Document No. : DSSNK-2601-B0-1

Notification of Polarizer on LCD Panel to PFAS-free

Product Name: TCG058WXLBPVNN-AN30

〈Schematic diagram〉
(for reference)

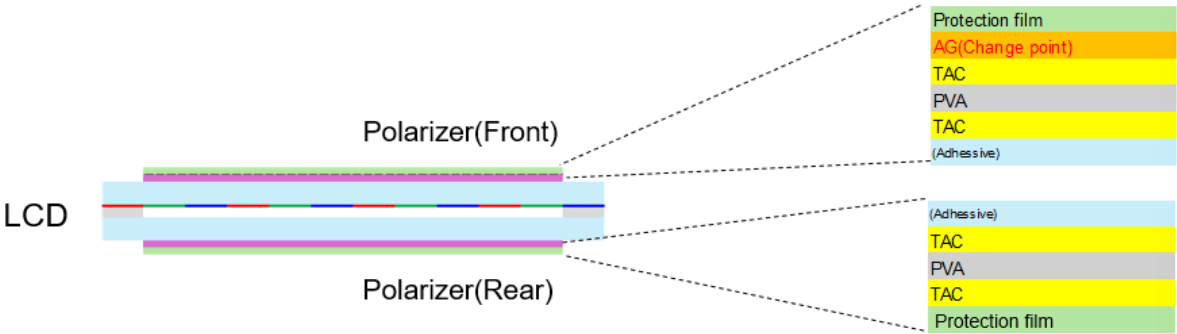
Applicable Component: Polarizer

* Photo shown: 12.1" panel.

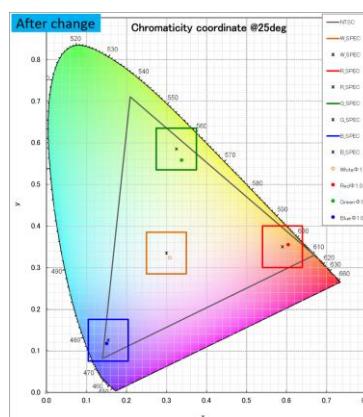
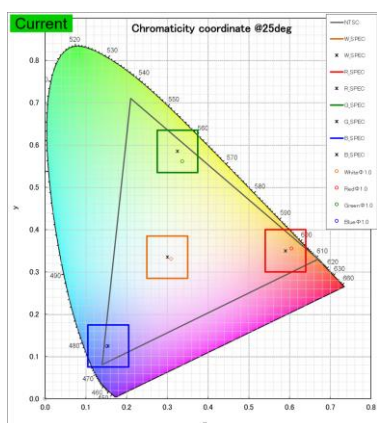
Item	Current	After change	Comment
AG (anti-glare) material	Contains PFAS	PFAS-free	Front polarizer
Appearance Difference			Same appearance as the current model.

Item	Change (Yes/No)	Comment	Note
Appearance	No	Please refer to the photo above.	
Optical Performance	No	Please refer below.	※
Reliability	No	Please refer below.	※
Specification Document	No	There will be no change in product name or revision of the specification sheet.
